**CITY OF SNELLVILLE  
DEPARTMENT OF PLANNING & DEVELOPMENT  
PLANNING COMMISSION**

**CASE NUMBER:** #CUP 18-03

**REQUEST:** Request for Conditional Use Permit for a Retail Automotive Parts Store and Request for Variances

**DEVELOPMENT/PROJECT:** O'Reilly Auto Parts Store

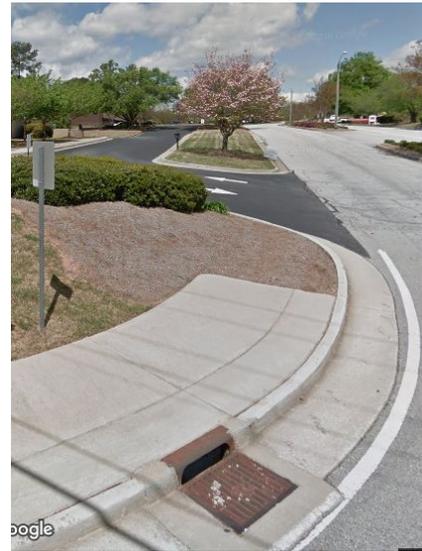
The concept plan shows the front parking lot, beginning at and running parallel to the front property line with a concrete retaining wall and fence beginning midway and running west to the western front corner of the property. Although there is a large sodded area located between the front parking row/retaining wall and public sidewalk, this area is within the public right-of-way and not part of the front landscape strip.

The concept plan accurately depicts the location of the 10 foot required front landscape strip. Shifting or reducing the building footprint will allow implementation of the front landscape strip for the planning of trees and shrubbery which will help to create a more aesthetically pleasing visual quality from the W. Main Street perspective. The Planning Department recommends denial of this request.

The concept plan shows 24 parking spaces in front of the building and 15 parking spaces on the corner side of the building, with no parking in the side or rear of the building. As shown on the concept plan, there are a total of 39 parking spaces, requiring no more than 8 spaces be located in front of the building and no more than 8 spaces be located to the side of the building, with the remaining 23 spaces to be located behind the building. Relocating the building closer to the front and corner side would achieve greater compliance with this requirement.

The concept plan also shows the addition of a full-access curb cut on Fountain Drive. Currently there are two existing curb cuts at each end of the property along Fountain Drive, with the northern curb cut remaining for possible future development. The southernmost existing curb cut may need to be relocated so that it sits back at least 125 feet from the Fountain Drive and W. Main Street intersection.

There are two neighboring commercial parcels, to the north and to the west. The concept plan shows the removal of most of the impervious surface on the rear of the property. As a result, access to the parcel to the north along Fountain Drive would not be practical due to the distance created. The neighboring parcel to the west is a 25± foot wide strip of asphalt that connects the bulk of the property to W. Main Street, though

there is no curb cut. Requiring access to this parcel would be impractical, and would require guests to then cross into the following parcel to exit the property. Though not requested by the applicant, this variance is reasonable.
